TX RX Systems Inc.
8625 Industrial Parkway
Angola, NY 14006
716-549-4700
Fax: 716-549-4772

This letter is in response to your request for verification of the addition which has been included into the signal booster model number 61-83B-50, FCC ID: EZZ5PI618350, IC ID: 1940A-PI618350. This addition includes an assembly (Fig. 1) added to the backup DC power input terminals to reduce the conducted emissions (referred to as the 30 VDC supply by Ultratech).

Fig.1

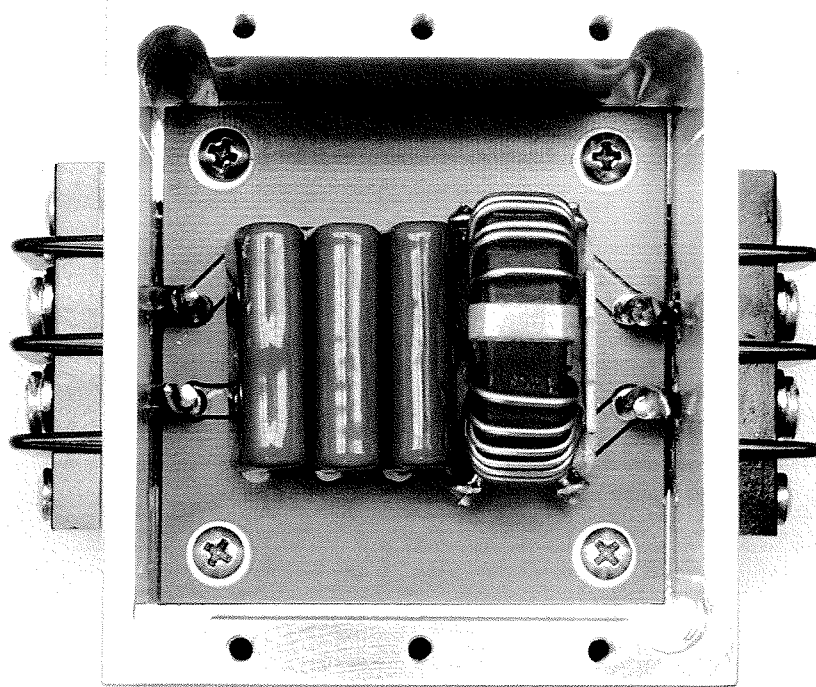
This assembly consists of three capacitors and one inductor. The capacitors are Panasonic part number ECQ-E2225KB, which are 2.2 μ fd, 250V, metallized polypropylene film, non-polarized. TX RX System has assigned part number 8-20967. The inductor is a JW Miller part number 8108, which is 1mH, 10A inductor. TX RX has assigned part number 8-21128. This assembly has already been added to the bill of materials for this model booster, and will be configured in all of these boosters prior to shipment.
